Heavy Vehicle Local Road Report for Use of Local Roads

Hunter Street East Construction Site - Rev B

Project number	7040
Document number	SMWSTETP-JCG-SCB-SN100-TF-RPT-093006

Hunter Street East – Proposed Haulage Routes

PROJECT	SYDNEY METRO WEST - EASTERN TUNNELING PACKAGE		
TITLE	SWEPT PATH ANALYSIS - GRESHAM STREET AND BENT STREET AS2890.2 12.5m HEAVY RIGID VEHICLE

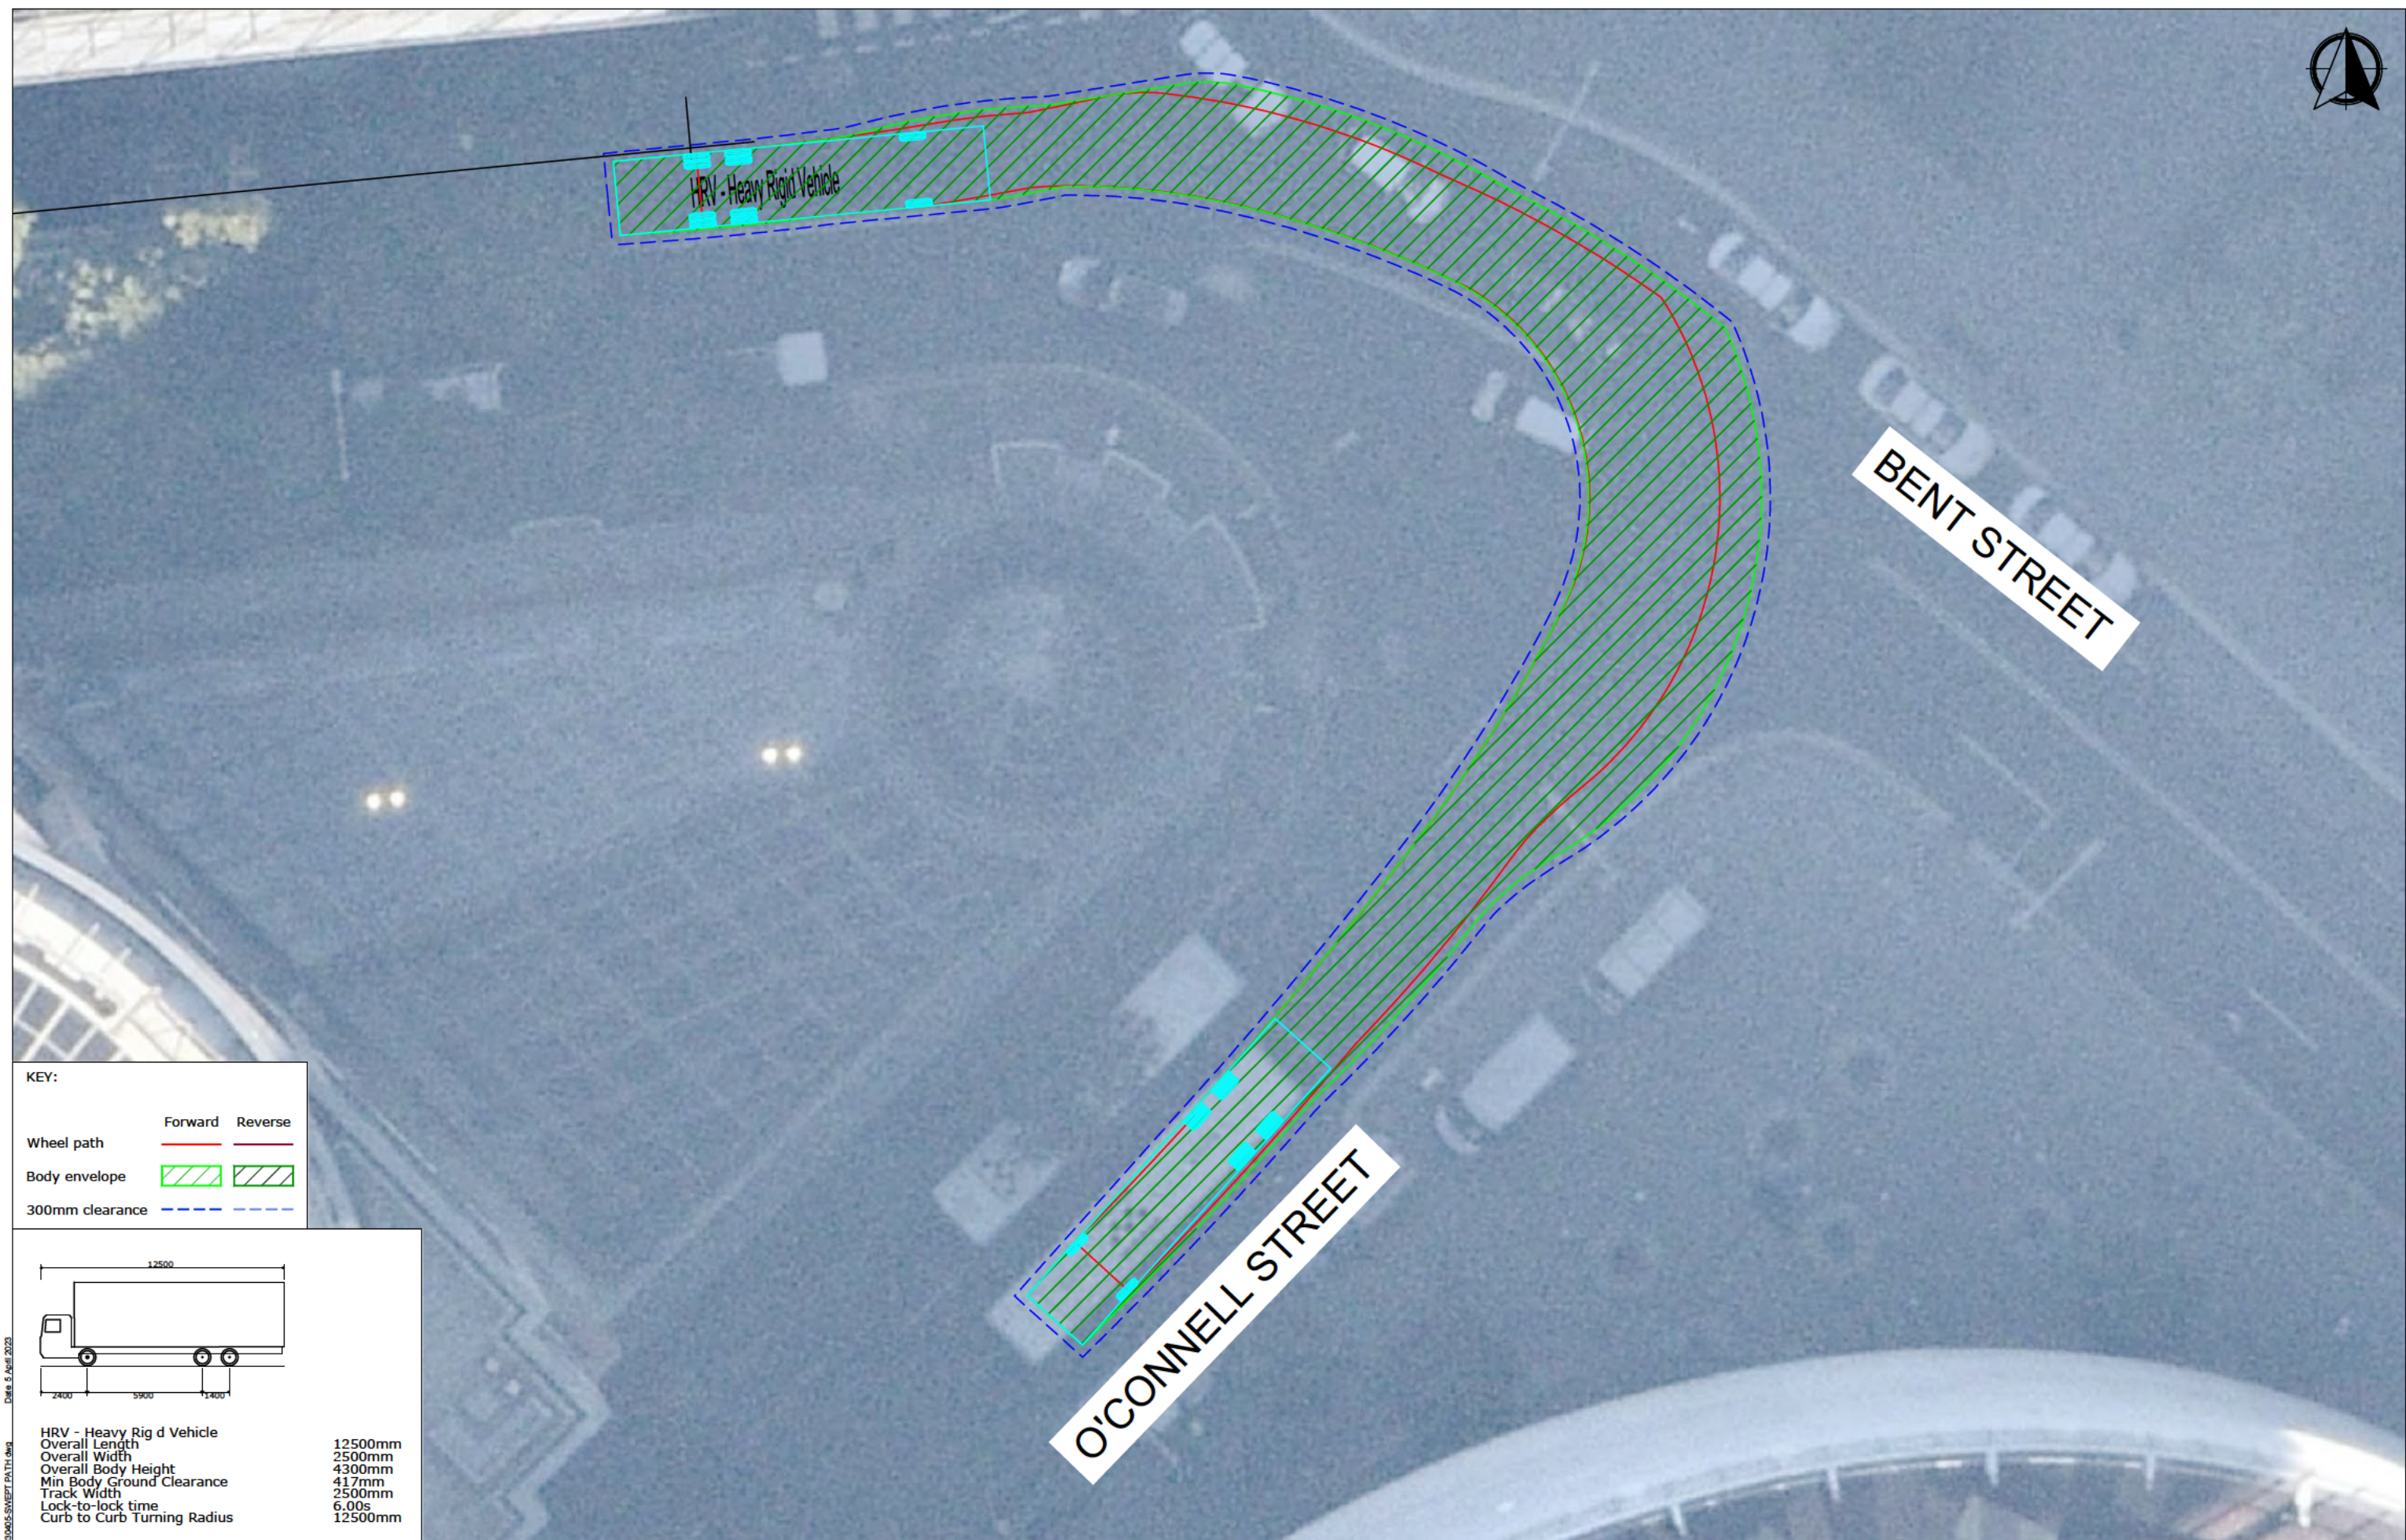
Designer responses are shown in the last column in Table 4.2 in the road safety audit report in Appendix B. Swept path diagrams have been revised and are shown in Appendix C in response to the audit findings.

Filename: 21480CAD-HU-FIGURE 12-230405-SWEPT PATH.dwg Date: 5 April 2023
